DRESDEN NUCLEAR POWER STATION

UNIT 3

PLANT DESIGN AND ANALYSIS REPORT

AMENDMENT NO. 2
ANSWERS TO AEC QUESTIONS

FIG. 6-1

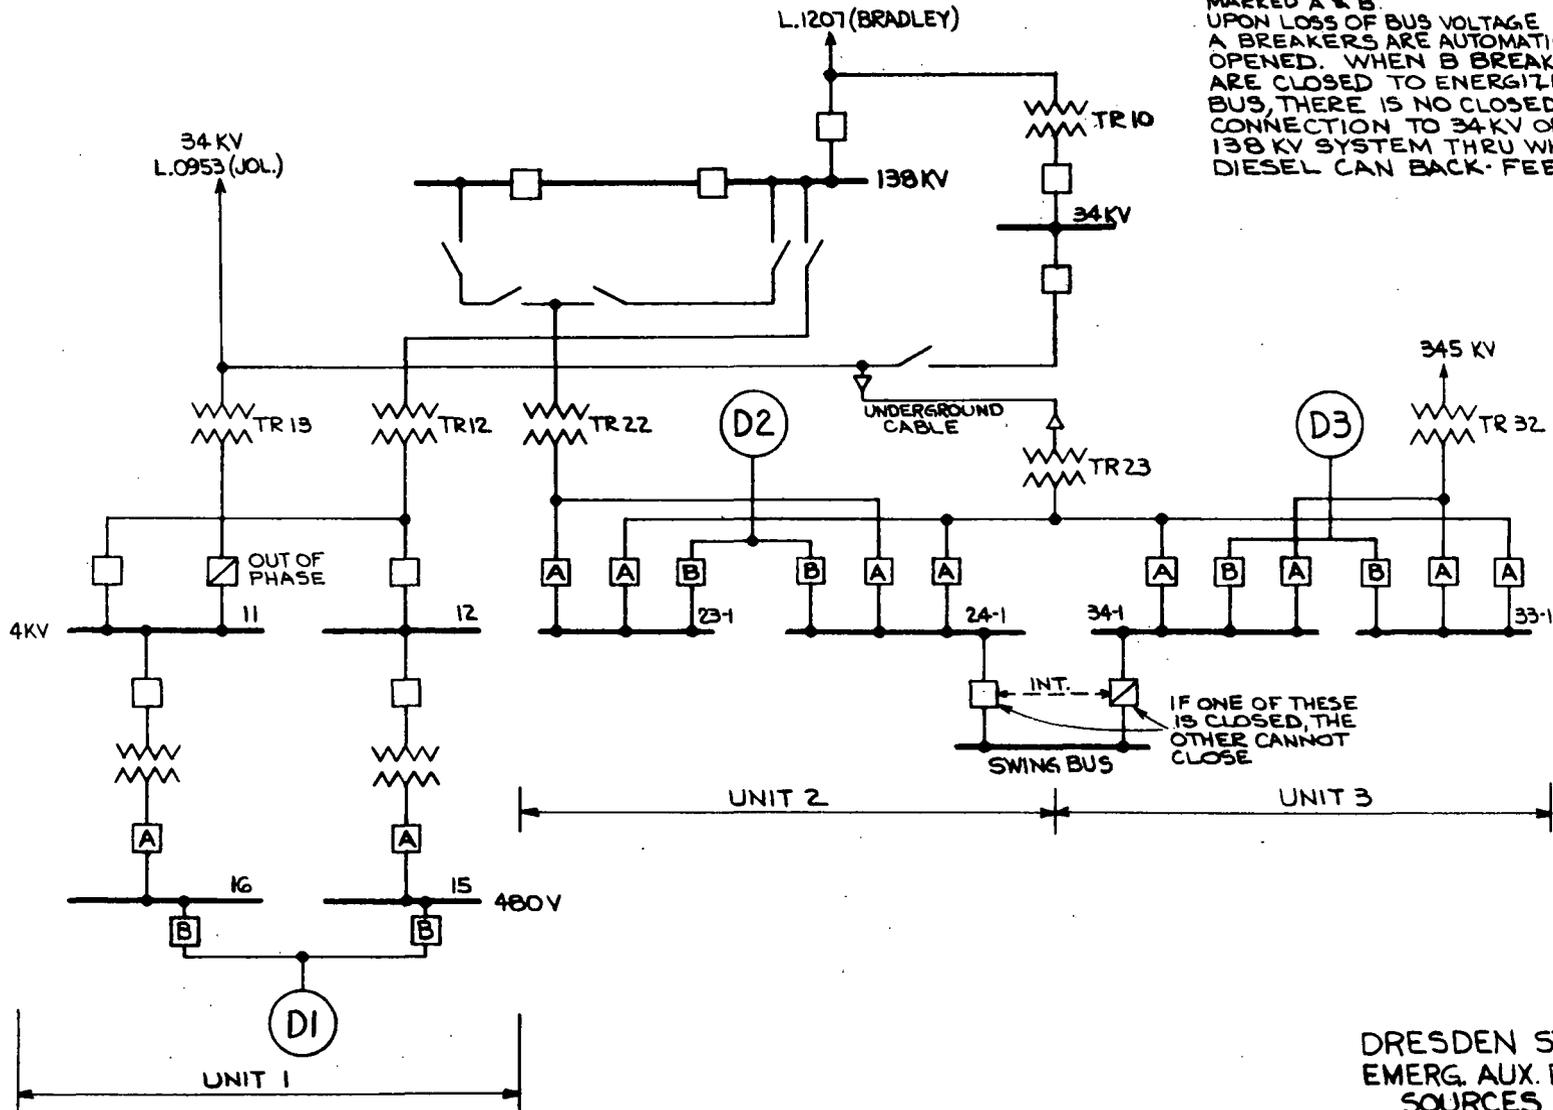
Please clarify the following interrelationships between the units of the Dresden Power Station caused by the station electrical system:

One 4.16 KV auxiliary power bus in Unit 2 and one in Unit 3 are interconnected to the 34.5 KV standby power source which is connected to the standby power system of Unit 1 and the 138 KV station bus. The 4.16 KV swing bus that provides power for the containment cooling system shared by Unit 2 and by Unit 3 is connected to one 4.16 auxiliary power bus in Unit 2 and one in Unit 3. Considering that the diesel generators for Unit 2 and for Unit 3 (which are the primary emergency power sources) can make connections to the 4.16 KV emergency power buses in the other unit, please clarify the bases which would lead to the conclusion that emergency and standby power sources for all three units are truly separable and that these interconnections in the station electrical system do not provide an adverse interaction between units during normal and abnormal modes of operation in the station.

1. The 4.16 KV swing bus can only be energized from one source at a time. This is accomplished by means of interlocks on the two supply circuit breakers which prevent closing of either breaker when the other is closed. This method of interlocking will prevent the interconnection of the auxiliary power systems of Dresden, Units 2 and 3.

2. In the accompanying sketch, the circuit breakers marked "A" open automatically upon loss of bus voltage by means of bus under voltage relays. When the circuit breakers marked "B" are closed to energize the auxiliary power buses from the diesel engine generators, all other power source circuit breakers will be open preventing the diesel engine generators from backfeeding into the other sections of the auxiliary power systems.

3. The design of the swing bus interlocks has not yet been finalized. However, interlocks of the electrical type employing auxiliary contacts on the breakers will probably be used. It has been found that interlocks of this type are very reliable and require little maintenance.

The A breakers (Figure 6-1) fed from transformer 23 to buses 23-1 and 24-1 will have closing feed through the (b) contacts of the A breakers in series of transformer 23 to buses 34-1 and 33-1 to prevent transformer 23 from being closed to Dresden 2 auxiliary buses if either breaker of transformer 23 to Dresden 3 auxiliary buses is closed. Likewise the closing feeds of the A breakers of

transformer 23 to buses 34-1 and 33-1 will be through (b) contacts of transformer No. 23 breakers to Dresden 2 auxiliary buses.

SIGNIFICANCE OF CIRCUIT BREAKERS MARKED A & B. UPON LOSS OF BUS VOLTAGE A BREAKERS ARE AUTOMATICALLY OPENED. WHEN B BREAKERS ARE CLOSED TO ENERGIZE BUS, THERE IS NO CLOSED CONNECTION TO 34KV OR 138KV SYSTEM THRU WHICH DIESEL CAN BACK-FEED.

IF ONE OF THESE IS CLOSED, THE OTHER CANNOT CLOSE
